AGENDA
RANCHO PALOS VERDES TRAFFIC SAFETY COMMITTEE
DECEMBER 11, 2017
CITY HALL COMMUNITY ROOM
7:00 P.M.

SUBJECT: TRACT 50666 – PHASE II OF TRUMP NATIONAL LOS ANGELES DEVELOPMENT - REVIEW OF THE TRAFFIC STUDY AND GEOMETRIC LAYOUT

**SUBJECT: TRACT 50666 – PHASE II OF TRUMP NATIONAL LOS
ANGLES DEVELOPMENT OPTIONAL INGRESS/EGRESS
ANALYSIS**

Figure 2 - Option #2

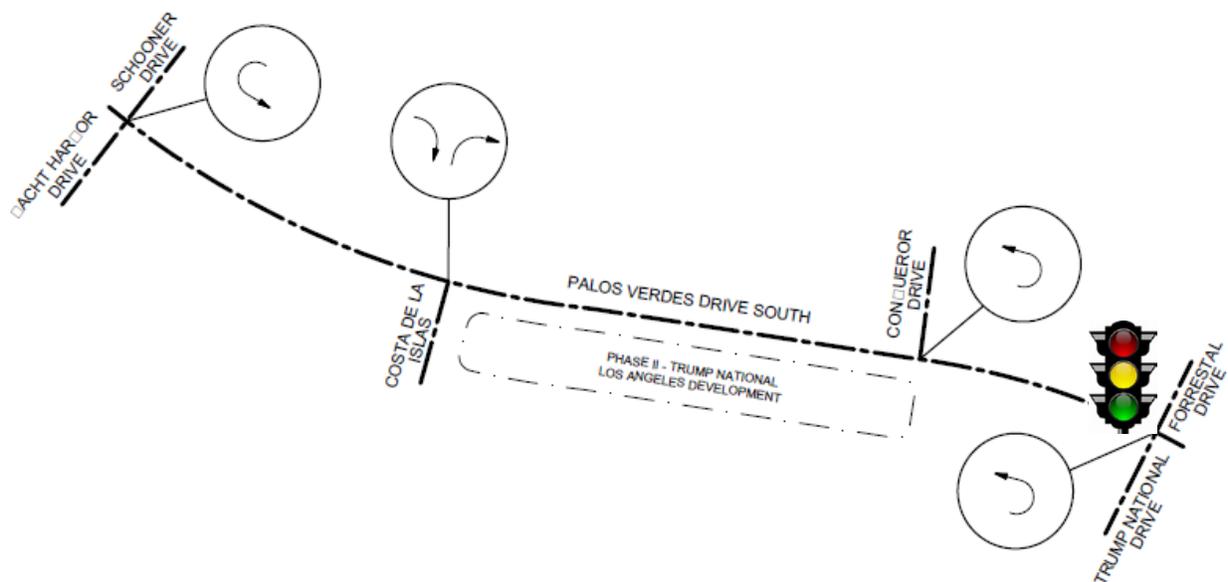
By restricting left turns into and out of the Costa De La Islas, westbound motorist who wish to enter the development will be required to make a U-turn at Schooner Drive/Yacht Harbor Drive. Likewise, motorists who wish to exit the development and travel west must first go east on Palos Verdes Drive South and then make a U-turn at Conqueror Drive or at Trump National Drive/Forrestal Drive. While safety may be improved at Costa De La Islas by eliminating two turning movements, drivers will now be forced to make U-turns at adjacent intersections. The sight distance at Schooner Drive/Yacht Harbor Drive, Conqueror Drive, and Trump National Drive/Forrestal Drive should be evaluated to confirm that sight distance is adequate for drivers to safely navigate the U-turn. Factors such as fog, available roadway lighting, and intersection geometry should be considered as well. Drivers of large vehicles (30 feet or longer) such as motorhomes, delivery trucks, and fire apparatus may have trouble negotiating U-turns at Schooner Drive/Yacht Harbor Drive, Conqueror Drive, and Trump National Drive/Forrestal Drive. The size and geometry of the intersections are such that a multi-point U-turn will likely be necessary. Negotiating a multi-point U-turn could increase the potential for collisions at these intersections. Passenger vehicles can negotiate the U-turns without issue.

Figure 3 - Option #3

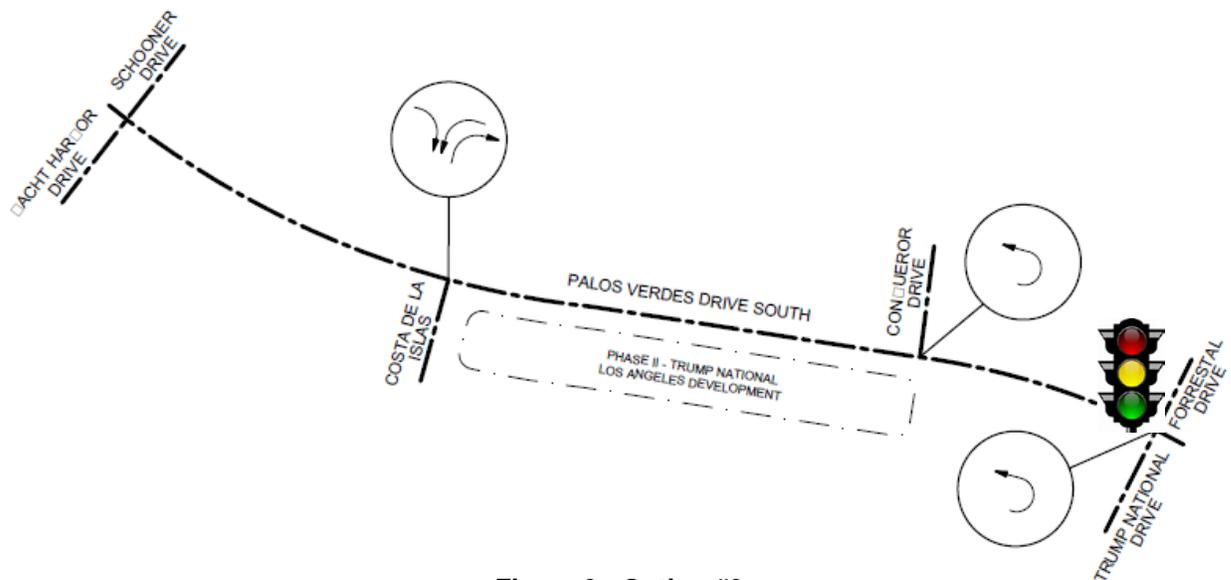
Option 3 proposes to provide right turn in, right turn out, and westbound left turn in access to Costa De La Islas. Northbound left turns will be physically restricted by the modified raised center median. A new traffic signal at Palos Verdes Drive South and Trump National Drive/Forrestal Drive is also proposed under this option.

Option 3 reduces turning movement conflicts between vehicles, pedestrians, and bicyclists because left turns out of Costa De La Islas will be restricted. According to available accident data, broadside type collisions have a higher occurrence in this area with drivers failing to stop at the stop sign or failing to yield to oncoming traffic. Restricting northbound left turns at Costa De La Islas has the potential to eliminate broadside collisions at the intersection. The median break will be constructed to allow westbound left turns into the development only, but will restrict northbound left turns out. Because a westbound acceleration lane is not required, the existing median width can mostly be maintained.

By restricting left turns out of Costa De La Islas, motorists who wish to exit the development and travel west must first go east on Palos Verdes Drive South and then make a U-turn at Conqueror Drive or at Trump National Drive/Forrestal Drive. While safety may be improved at Costa De La Islas by eliminating one turning movement, drivers will now be forced to make U-turns at adjacent intersections. The sight distance at Conqueror Drive and Trump National Drive/Forrestal Drive should be evaluated to confirm that sight distance is adequate for drivers to safely navigate the U-turn. Factors such as fog, available roadway lighting, and intersection geometry should be considered as well.

Drivers of large vehicles (30 feet or longer) such as motorhomes, delivery trucks, and fire apparatus may have trouble negotiating U-turns at Conqueror Drive and Trump National Drive/Forrestal Drive. The size and geometry of the intersections are such that a multi-point U-turn will likely be necessary. Negotiating a multi-point U-turn could increase the potential for collisions at these intersections. Passenger vehicles can negotiate the U-turns without issue.

Based on the options evaluated, staff concurs with Willdan’s conclusion that Option #1 is the safest option compared to Option #2 or Option #3. Option #1’s design is consistent with industry standards and makes accommodations for large and emergency vehicles. Staff is requesting the TSC to evaluate the presented options or any other feasible option and formulate a recommendation that will be forwarded to the applicant via the Community Development Department.

OPTION 1 TURNING MOVEMENTS
RIGHT TURN IN/RIGHT TURN OUT AT COSTA DE LA ISLAS

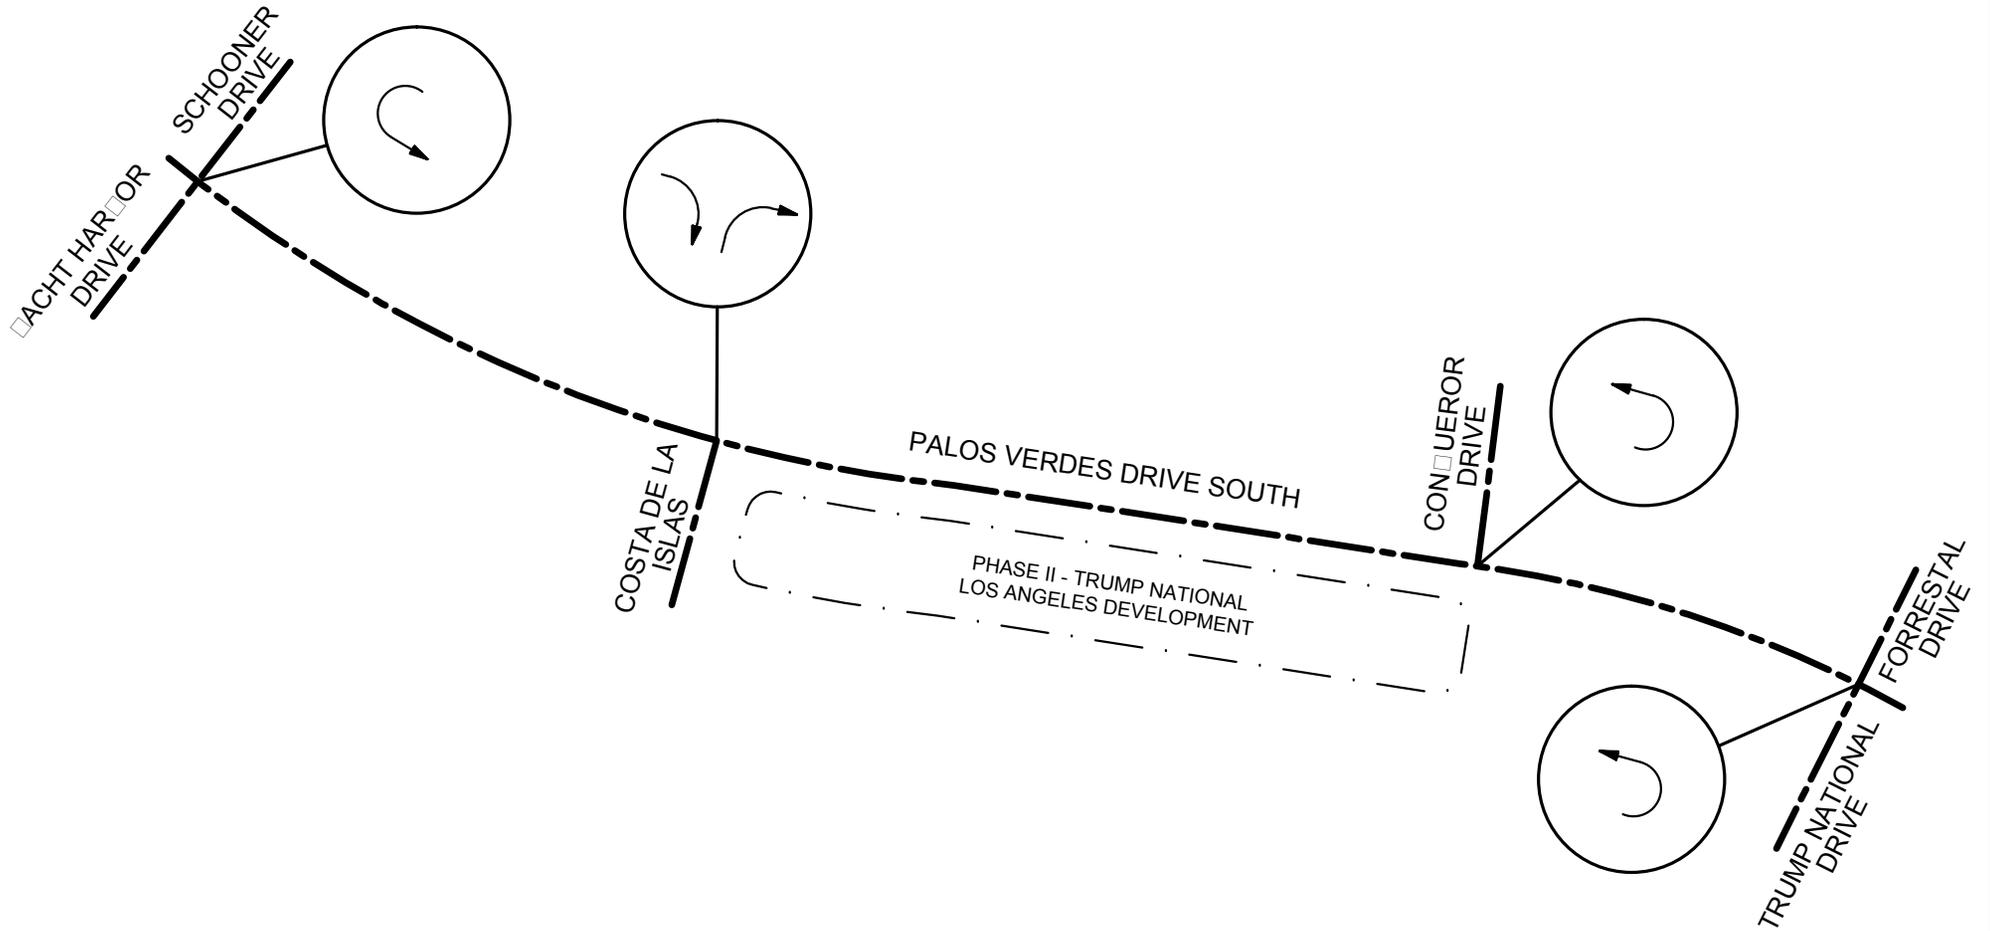
Option 2 proposes to provide only right turn in and right turn out access to Costa De La Islas. Westbound left turns and northbound left turns will be physically restricted by the existing raised center median. A new traffic signal at Palos Verdes

Option 2 reduces turning movement conflicts between vehicles, pedestrians, and bicyclists because left turns into and out of Costa De La Islas will be restricted. According to available accident data, broadside type collisions have a higher occurrence in this area with drivers failing to stop at the stop sign or failing to yield to oncoming traffic. Restricting left turns at Costa De La Islas has the potential to eliminate broadside collisions at the intersection. Because no median break will be constructed the existing median width can be maintained.

By restricting left turns into and out of the Costa De La Islas, westbound motorist who wish to enter the development will be required to make a U-turn at Schooner Drive/Yacht Harbor Drive. Likewise, motorists who wish to exit the development and travel west must first go east on Palos Verdes Drive South and then make a U-turn at Conqueror Drive or at Trump National Drive/Forrestal Drive. While safety may be improved at Costa De La Islas by eliminating two turning movements, drivers will now be forced to make U-turns at adjacent intersections. The sight distance at Schooner Drive/Yacht Harbor Drive, Conqueror Drive, and Trump National Drive/Forrestal Drive should be evaluated to confirm that sight distance is adequate for drivers to safely navigate the U-turn. Factors such as fog, available roadway lighting, and intersection geometry should be considered as well.

Drivers of large vehicles (30 feet or longer) such as motorhomes, delivery trucks, and fire apparatus may have trouble negotiating U-turns at Schooner Drive/Yacht Harbor Drive, Conqueror Drive, and Trump National Drive/Forrestal Drive. The size and geometry of the intersections are such that a multi-point U-turn will likely be necessary. Negotiating a multi-point U-turn could increase the potential for collisions at these intersections. Passenger vehicles can negotiate the U-turns without issue.

OPTION 3 TURNING MOVEMENTS

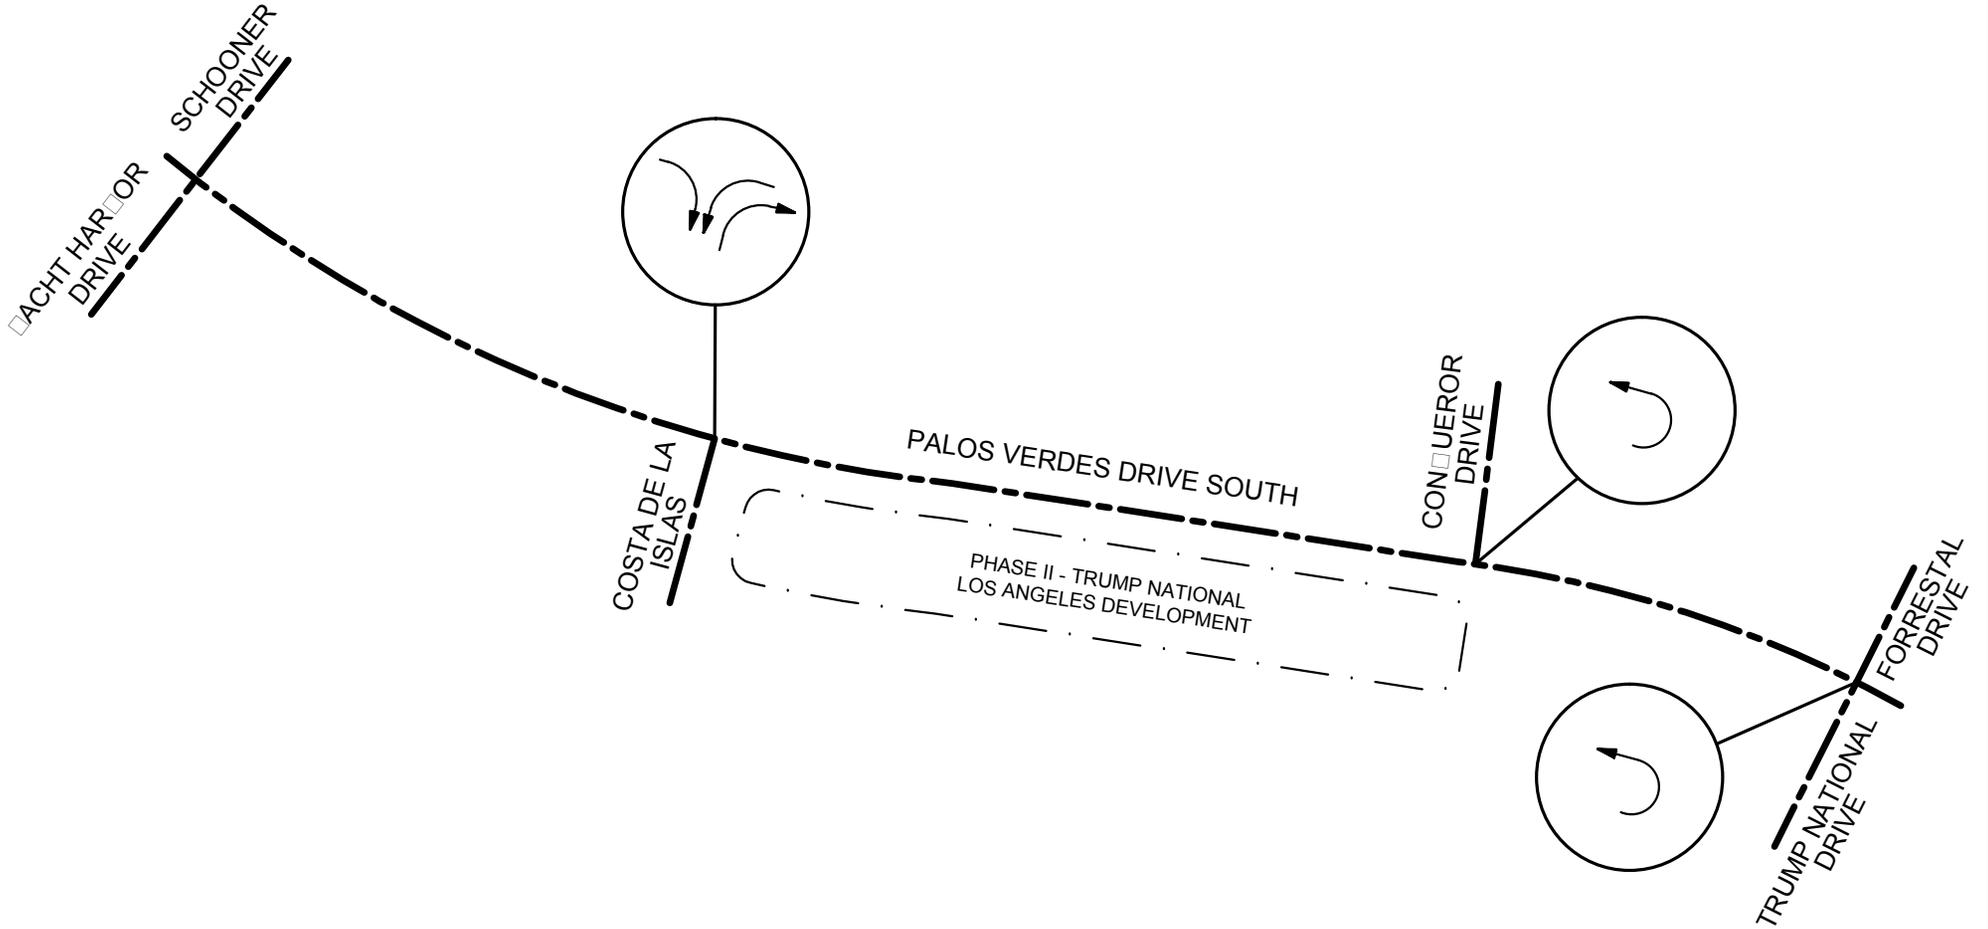
Option 3 proposes to provide right turn in, right turn out, and westbound left turn in access to Costa De La Islas. Northbound left turns will be physically restricted by the modified raised center median. A new traffic signal at Palos Verdes Drive South and Trump National Drive/Forrestal Drive is also proposed under this option.

Option 3 reduces turning movement conflicts between vehicles, pedestrians, and bicyclists because left turns out of Costa De La Islas will be restricted. According to available accident data, broadside type collisions have a higher occurrence in this area with drivers failing to stop at the stop sign or failing to yield to oncoming traffic. Restricting northbound left turns at Costa De La Islas has the potential to eliminate broadside collisions at the intersection. The median break will be constructed to allow westbound left turns into the development, but will restrict northbound left turns out. Because a westbound acceleration lane is not required, the existing median width can mostly be maintained.

By restricting left turns out of Costa De La Islas, motorists who wish to exit the development and travel west must first go east on Palos Verdes Drive South and then make a U-turn at Conqueror Drive or at Trump National Drive/Forrestal Drive. While safety may be improved at Costa De La Islas by eliminating one turning movement, drivers will now be forced to make U-turns at adjacent intersections. The sight distance at Conqueror Drive and Trump National Drive/Forrestal Drive should be evaluated to confirm that sight distance is adequate for drivers to safely navigate the U-turn. Factors such as fog, available roadway lighting, and intersection geometry should be considered as well.

Drivers of large vehicles (30 feet or longer) such as motorhomes, delivery trucks, and fire apparatus may have trouble negotiating U-turns at Conqueror Drive and Trump National Drive/Forrestal Drive. The size and geometry of the intersections are such that a multi-point U-turn will likely be necessary. Negotiating a multi-point U-turn could increase the potential for collisions at these intersections. Passenger vehicles can negotiate the U-turns without issue.

Figure 4C-3. Warrant 3, Peak Hour

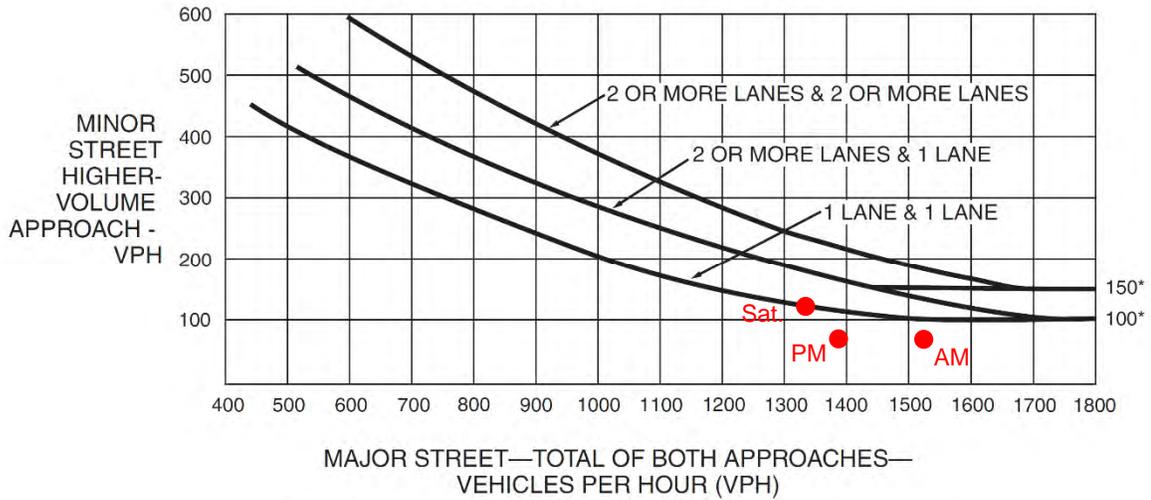
Warrant 3, Peak Hour, is intended for use at locations where traffic conditions are such that for a minimum of 1 hour of an average day, the minor street suffers undue delay when entering or crossing the major street. The warrant should be applied only in unusual cases, such as office complexes, manufacturing plants, industrial complexes, or high-occupancy vehicle facilities that attract or discharge a larger number of vehicles over a short amount of time. Trump National Golf Club Los Angeles is considered a high-occupancy vehicle facility as the location hosts weddings, tournaments, festivals, and other events that attract and discharge many vehicles in a short amount of time. Similarly, Ladera Linda Park located on Forrestal Drive north of Palos Verdes Drive South hosts weekend AYSO soccer competitions. The competitions attract and discharge large volumes of traffic in short periods of time throughout the course of the competitions.
